Reviewer 2

R2.1. The authors have developed a reservoir model, GLORY, that can be connected to the global integrated assessment model GCAM. This paper describes GLORY and reports the results of several preliminary experiments when connected to GCAM.

Figure 1. global total water demand from 2020 to 2050 across four scenarios.

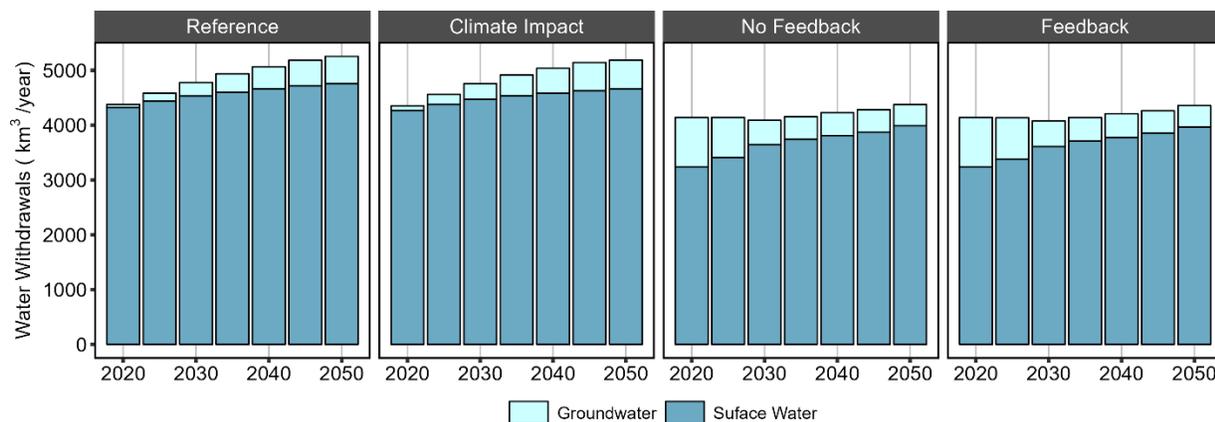
R2.27. Figure 10: Surface water withdrawal in the Indus River exceeds 300 km³ year⁻¹ for the Reference and Climate Impact scenarios, which is greater than the mean annual runoff (140 km³ year⁻¹). How could this happen? For the No Feedback and Feedback scenarios, the usage of groundwater will sharply decrease after 2030. How could this be achieved? All in all, what will be the global total water withdrawal in 2050 for each scenario? What will be the global total reservoir capacity for each scenario?

Thank you for your feedback. The *Reference* and *Climate Impacts* scenarios use the *existing* GCAM supply curve approach (i.e., the “old” approach), wherein for Indus River basin, historical groundwater depletion and historical demand is used to calculate the accessible renewable water based on Eq. 2:

Calculating accessible water with Eq. 2 sometimes results in an improper amount of accessible water that exceeds the mean annual runoff. We have identified this inconsistency issue between data and

GCAM results in the current GCAM model, which needs improvement. With our new GLORY approach applied in *Feedbacks* and *No Feedbacks* scenarios, we have addressed this issue. Consequently, surface water withdrawals will always remain below the mean annual runoff.

Regarding non-renewable groundwater, GCAM assumes that non-renewable (i.e., fossil) groundwater will deplete irreversibly. Groundwater availability is categorized into several grades (e.g., grade 1, grade 2, ..., grade 10), with each grade permitting a certain amount of groundwater extraction at a specific price. As groundwater is depleted, it moves to higher grades where the price increases. Eventually, groundwater may become fully depleted or the price may become unaffordable. This is documented in Turner et al. (2019). From Figure 10, there is a significant decline in groundwater extraction after 2025 for the *Feedbacks* and *No Feedbacks* scenarios due to substantial extraction between 2020 and 2025. This depletion results in groundwater moving to higher-priced grades for future extraction. Ultimately, the Indus basin is one in which we observe the potential for a near-term peak and eventual decline in groundwater extraction in a recent study by our team (Niazi et al., in press), owing to groundwater's decreasing levels and thus economic accessibility in the Indus basin.

We have created Figure 1, illustrating the global total water demand from 2020 to 2050 across four scenarios. The future global total water demand shows a decrease of over 1000 km³/year from the previous approach (i.e., used in *Reference* and *Climate Impact* scenarios) to the new GCAM-GLORY approach (i.e., used in *No Feedback* and *Feedback* scenarios). Given that the socioeconomic assumptions remain consistent across all four scenarios in GCAM, the global total water demand remains relatively stable, with notable changes in the proportion of water supply sources (groundwater vs. surface water) in the new approach. In summary, the projected global total demand is approximately 5254, 5185, 4373, and 4356 km³/year by 2050 for the *Reference*, *Climate Impact*, *No Feedback*, and *Feedback* scenarios, respectively. The water supply reservoir storage capacity has increased by about 70 km³ by 2050 from historical existing storage capacity under *No Feedback* and *Feedback* scenarios, while it was assumed to remain constant for both *Reference* and *Climate Impact* scenarios. Please note that the increased capacity only pertains to water supply reservoirs, and the projected capacity expansion can vary significantly under different socio-economic drivers (e.g., population and GDP) in GCAM.
